MARION COUNTY GROWTH SERVICES

220203Z

Rezoning

Rezoning Request:

MODIFIED TYPE 'B'
BUFFER DETAIL
SCALE: N.T.S.

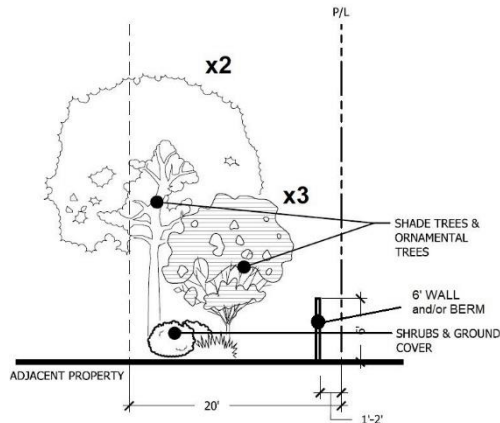
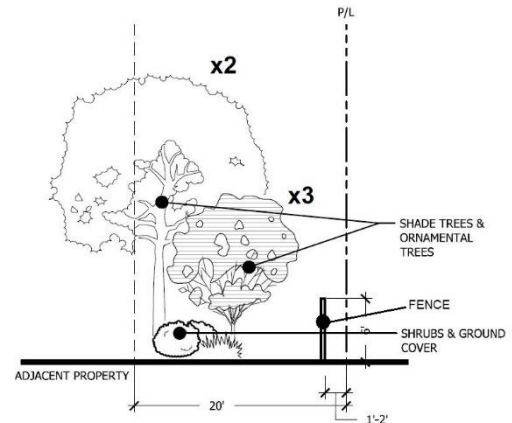
The PUD Conceptual Plan proposes various buffers along the project's perimeter, however no internal buffers between the PUD's uses are proposed. A Type 'C' Buffer is proposed along Interstate 75 and Hwy 318 consistent with LDC requirements. Along the site's south and west boundaries that abut agricultural lands, a Type 'B' Buffer (minimum 25' wide, minimum 6' high wall, two shade trees and three accent trees per 100 LF with shrubs and groundcover for at least 50% of the buffer area). The applicant proposes a Modified Type 'B' Buffer (minimum 20' wide, minimum 6' high privacy fence or berm, two shade trees and three accent trees per 100 LF with shrubs and groundcover for at least 50% of the buffer area – image below) replacing the wall with a minimum privacy fence.

Applicant's Proposed Type 'A' Buffer

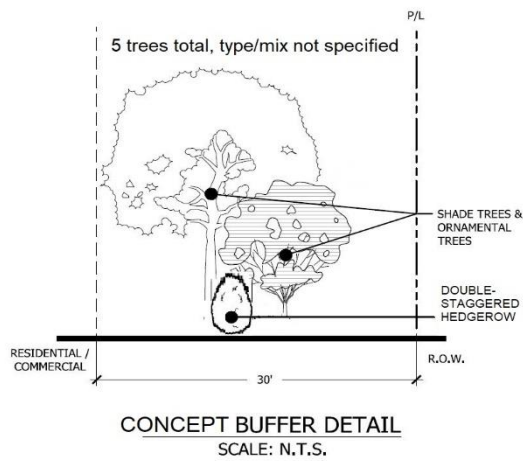
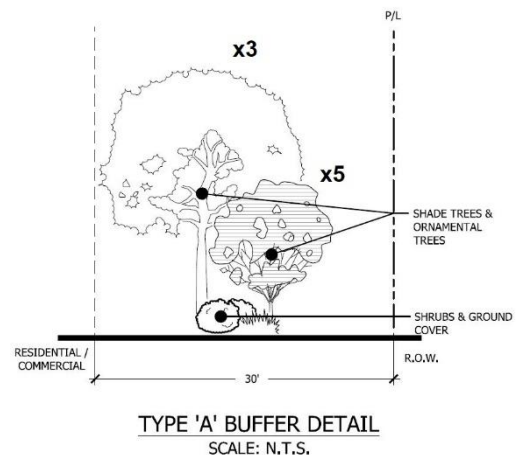
Along the site's boundaries for the north and southeast outparcel areas, the Irvine/Sunny Oaks RGAC Concept Plan proposed a specialized buffer to be 30' wide at a minimum with five unspecified trees per 100 LF and a double-staggered hedgerow. The applicant proposes to adjust the buffer design along the north outparcel area, and essentially revise the buffer type along the southeast outparcel.

The applicant proposes to provide the north outparcel area buffer as a Type 'A' Buffer (30' minimum width, with three shade trees and five accent ornamental trees, with shrubs and groundcover to reach a minimum of 3' within one year – image below) reducing the shrub component from a continuous double-staggered hedgerow. Staff has concerns regarding the removal of the continuous double-staggered hedgerow as the PUD site is expected to include large vehicle intensive operations such as distribution centers. *Staff recommends the double-staggered hedgerow requirement be maintained for understory visual screening; however, an opaque wall or fence, berm, or combination of them, may be provided as an alternative, with the selected method complying with LDC height requirements for such features.*

Applicant's Proposed Type 'A' Buffer

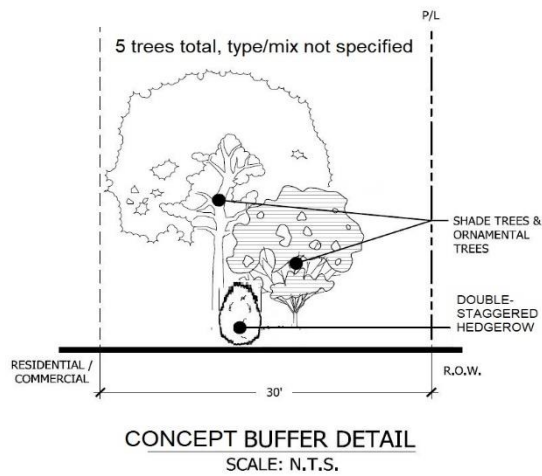
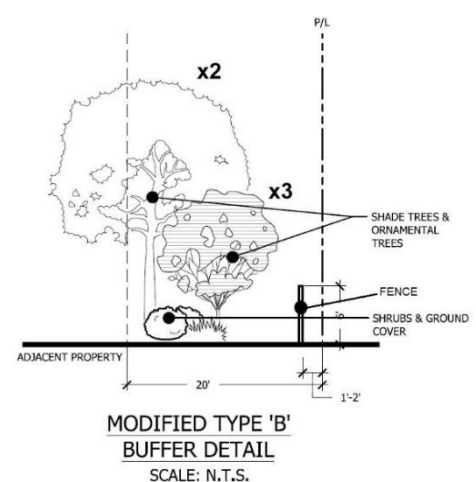
Along the site's boundaries for the southeast outparcel area, the applicant proposes to establish the previously noted Modified Type 'B' Buffer (minimum 20' wide, minimum 6' high privacy fence or berm, two shade trees and three accent trees per 100 LF with shrubs and groundcover for at least 50% of the buffer area – image below). The change specifies the type and mix of trees but reduces the buffer width by 10' to a minimum 20' wide and reducing the planting requirement from a double-staggered hedgerow to 50% shrub/groundcover while adding a fence requirement.
